# Service Kit 753-0718

CODE: CP-025

SUBJ: Locking Rod for Log Splitters

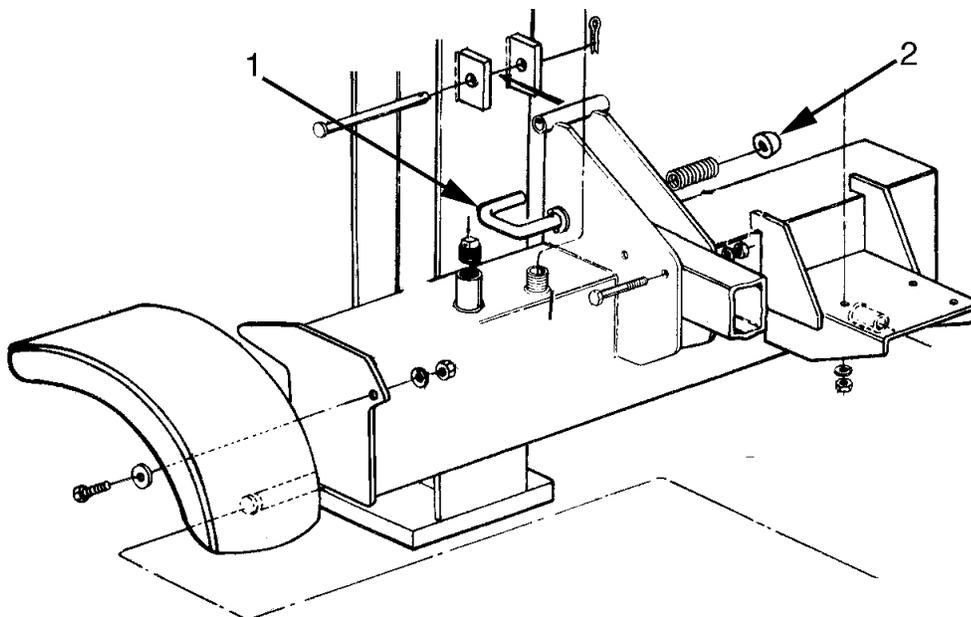
- **Problem:** Locking Rod (781-0370A) has been replaced with new locking Rod (781-0690)
- **Cause:** Locking Rod (781-0370A)
- **Solution:** Install Service Kit 753-0718

1. Remove the old Locking Rod (781-0370A) and hardware from the unit. Discard cotter pins because they will not be needed on new Locking Rod.
2. Install the new Locking Rod (**781-0690**) and replace the washers and the spring from the previous rod. Secure the Locking Rod with (**726-0214**) push cap supplied in the service kit. **See diagram below.**
